# UNITED STATES PATENT AND TRADEMARK OFFICE

10/723,389

<b>Office Action Summary</b>	<b>Application No.</b> 10/723,389	<b>Applicant(s)</b> VEARIEL ET AL.	
	<b>Examiner</b> DIMPLE N. BODAWALA	<b>Art Unit</b> 1791

### **DETAILED ACTION**

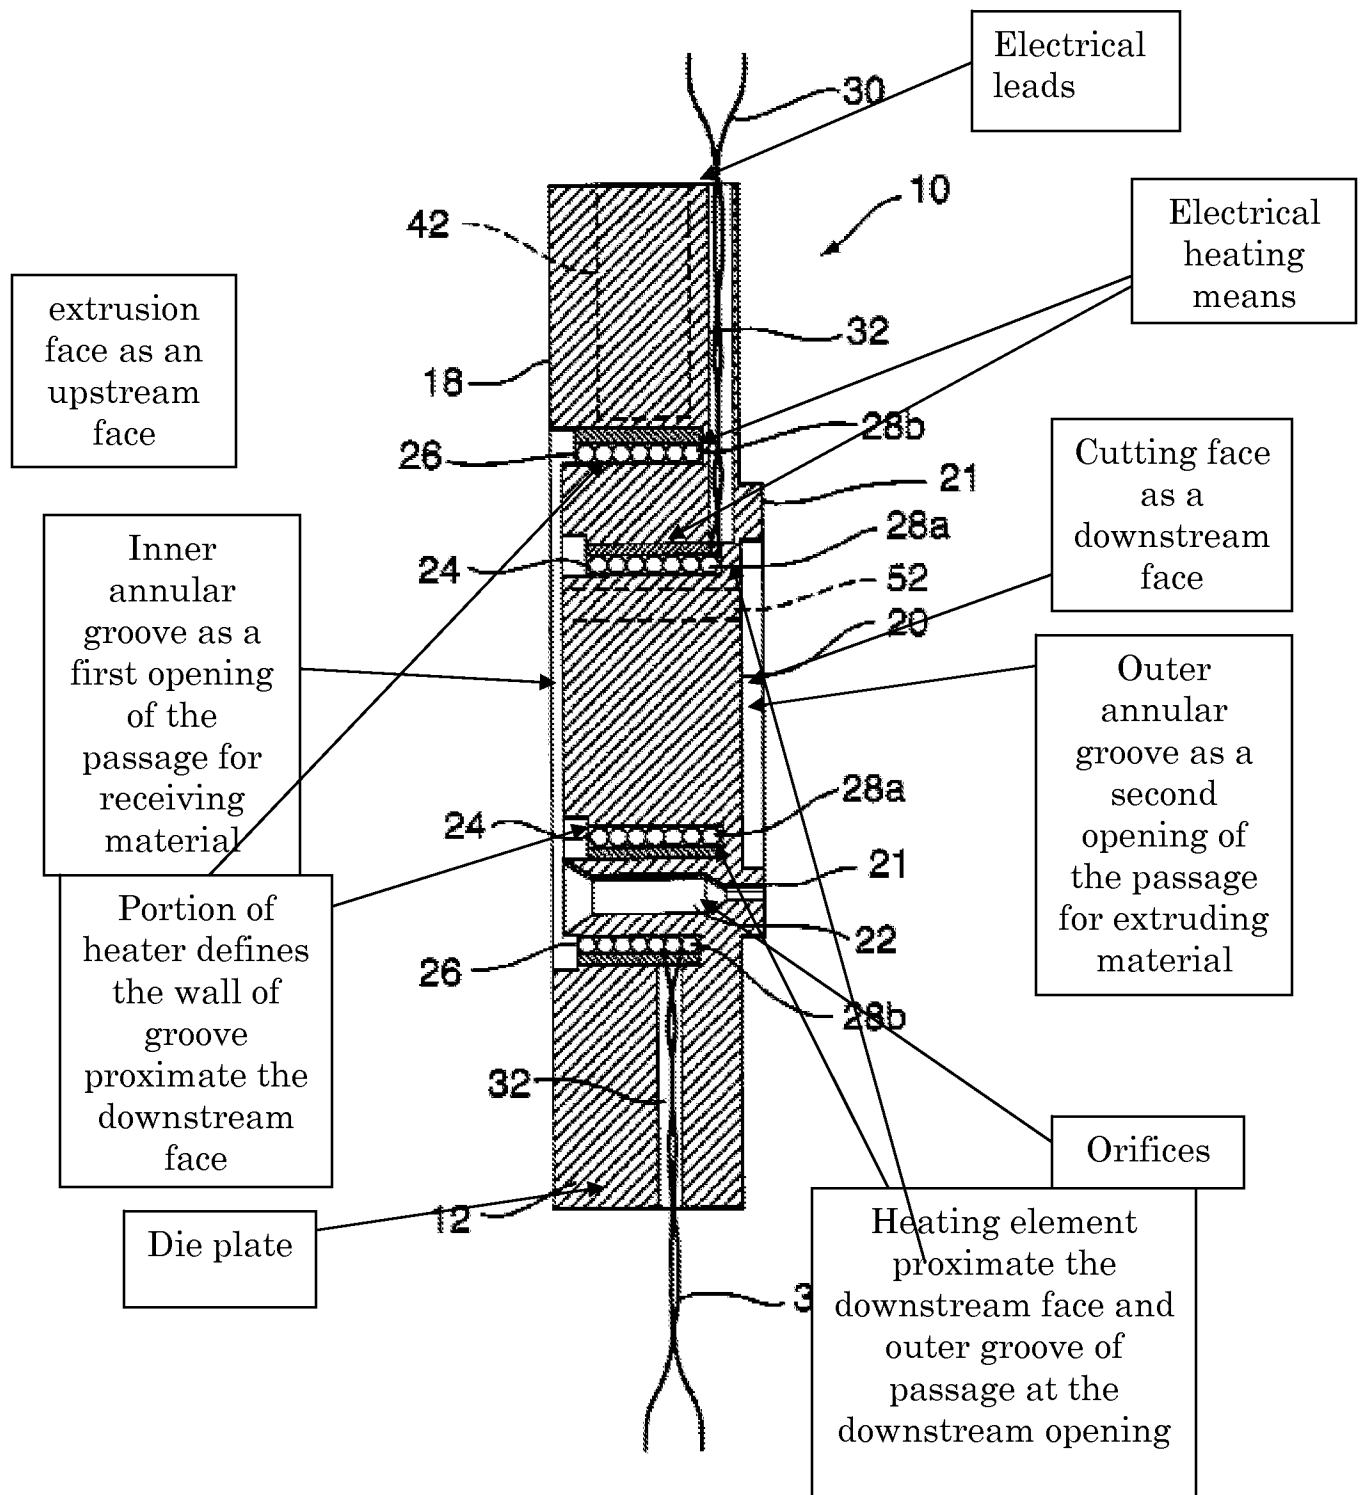
13. Courval et al teach a die plate having (Fig 31 #25) (a) an upstream face; (b) a downstream face; (c) at least one passage having a first opening in said upstream face whereby molten resin may be received and a second opening in said downstream face whereby molten resin may be extruded; and (d) a heater (Fig 3, #28) proximate said downstream face and proximate with said at least one passage at said downstream opening; the at least one passage is generally cylindrical and having a substantially uniform diameter from said upstream face to said downstream face (Fig 3); the heater is concentric with said at least one passage (Fig 3); the die plate is a monolithic die plate (Fig 3); die plate comprises a first plate having said upstream face and a second plate having said downstream face and said heater, said first and second plates fluidically connected by said at least one passage (the broadness of the claims shows that Courval et al reads on this, with #14 being the first plate and #25 being the second plate); the at least one passage passes through a portion of said heater, such that said portion defines the wall of said passage proximate said downstream face (an alternative embodiment of Courval et al reads on this, col. 8, lines 9-11); the die plate comprises a material selected from brass,

and stainless steel (col. 2, lines 40-55); an extrusion die assembly having a die plate having at least one passage including an initial, upstream zone comprised of an opening for receiving a polymer melt having a bulk temperature, an intermediate zone for conveying said polymer melt, and a final, downstream zone terminating said extrusion die assembly at an exit opening whereby said polymer melt exits said extrusion die assembly, further comprising a heating means for said downstream zone whereby at least a portion of said polymer melt may be locally heated to a temperature greater than T (Fig 3); the heating means comprises a heater concentric with the extrusion orifice pattern (Fig 3); the heating means is proximate said exit opening; the passage is generally cylindrical and having a substantially uniform diameter from said opening for receiving a polymer melt to said exit opening (Fig 3); the die plate is a monolithic die plate (Fig 1) the die plate comprises a first plate having an upstream face and comprising said upstream zone and a second plate having a downstream face and said heater, said first and second plates fluidically connected by said at least one passage (see discussion above); the die plate comprises a material selected from brass, and stainless steel(col. 2. lines 40-55); the second plate is a retrofit part (See Fig 3). Courval ('045) discloses the heater near by the die plate. It further discloses the temperature range of the molten material, which is about 30 C

to 145 C. It further teaches that the temperature range of the molten polymer is depending on the polymer shape as a result of deformation force upon it (See coi.5 lines 9-43, and example 2). It further discloses a heater comprises a band heater, which inherently suggests the band heater as an electrical heating means.

Above figure from the prior art indicates the cross sectional views of the die plate of extrusion die assembly.

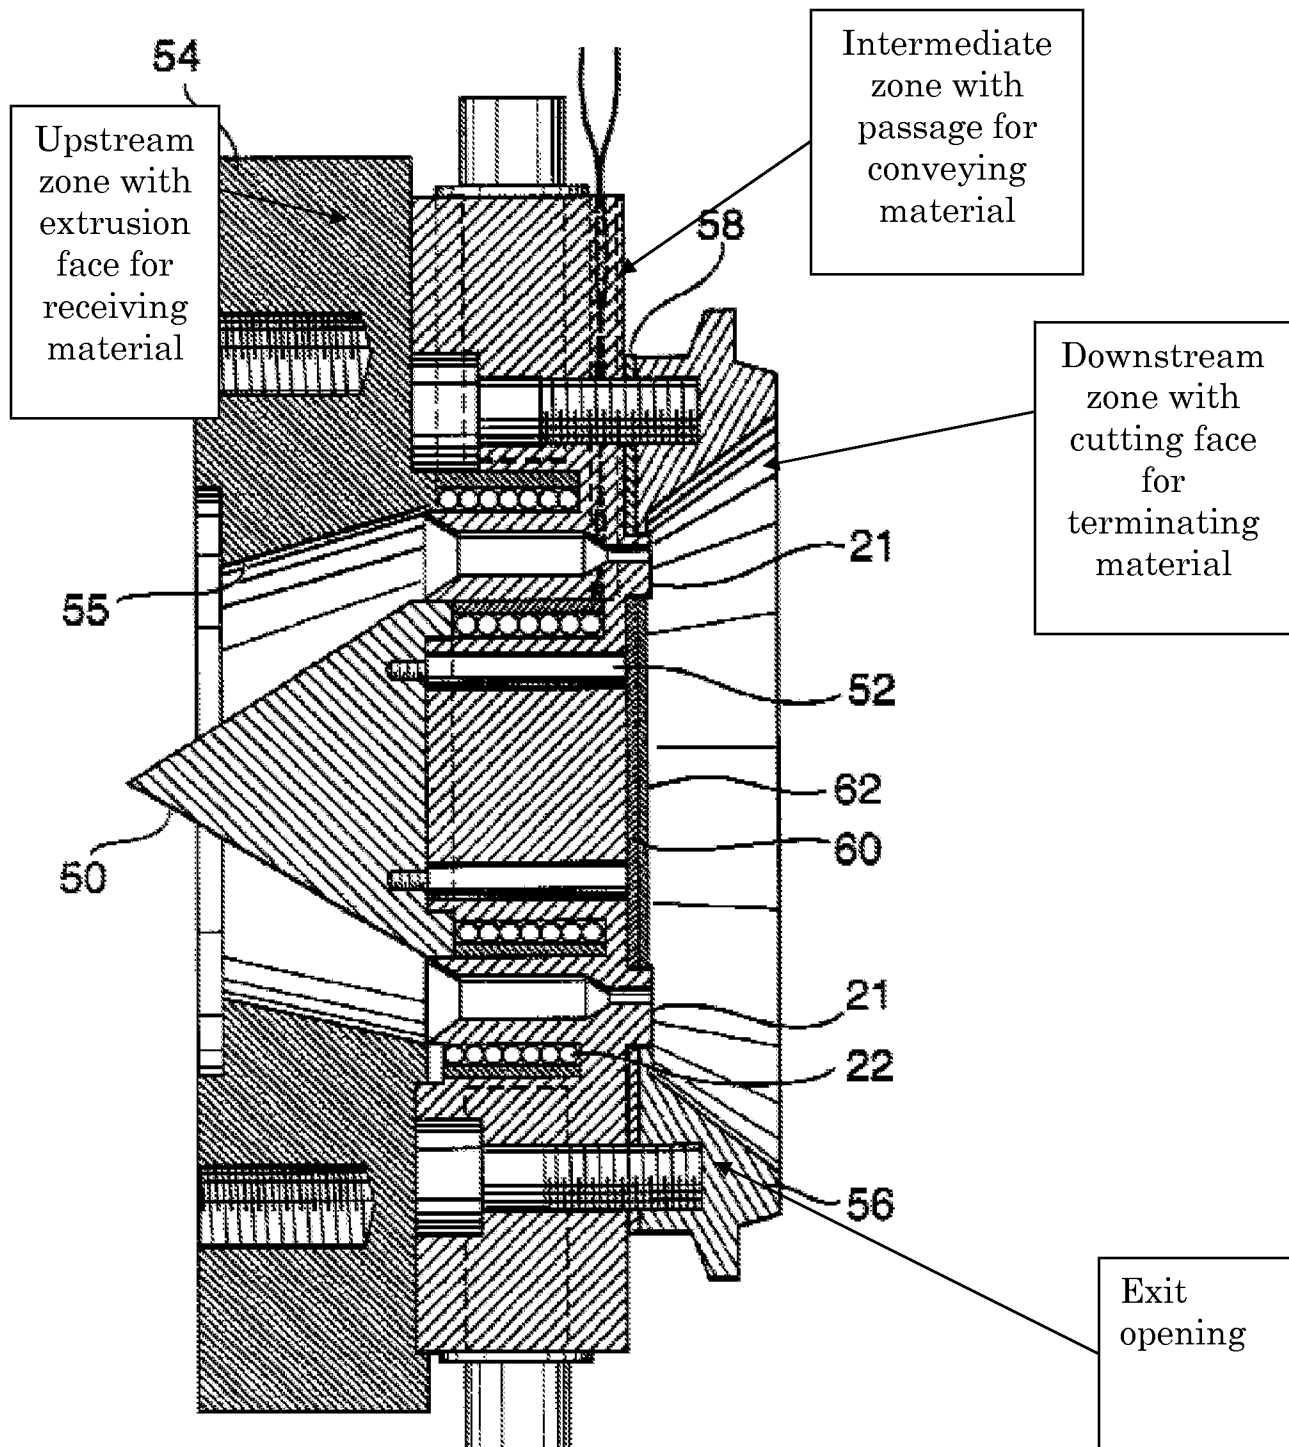
17. Ready et al. ('969) discloses an extrusion die assembly (10) comprising a die plate (12) (See figure 3) for preparing pellets (See col.1 lines 11-15), wherein plate is made of steel (See col.3 lines 25-27) and having an extruder face as an upstream face (18); a cutting face as a downstream face (20); annular inner and outer groove (24,26) as at least one passage for receiving the material and second opening for extruding material in downstream face (20) direction (See figure 3); and an electrical heating element (28a,28b) proximate the downstream face and proximate with the one passage (24,26) at the downstream opening (see figure 3; col.4 lines 4-10), wherein the electrical heating element which inherently capable of locally heating the molten resin with the electrical heating elements. Figure 3 further teaches that the portion of the heaters (28a,28b) defines the wall of the passage (24,26) proximate the downstream face. It further teaches that the annular passage (24,26) is filled with a thermally conductive paste so that heat from heating element (28a,28b) may be properly conducted to orifice (22) (See col.4 lines 11-20), which inherently suggests that the insulation material

concentric with the passage and contiguous with the portion of the heating element which defines the wall of the passage, wherein the passage proximate opening of the downstream face for extruding the material.

Therefore, Reddy et al. ('969) discloses all claimed structural limitations as discussed above, and, thus, the claims are anticipated.
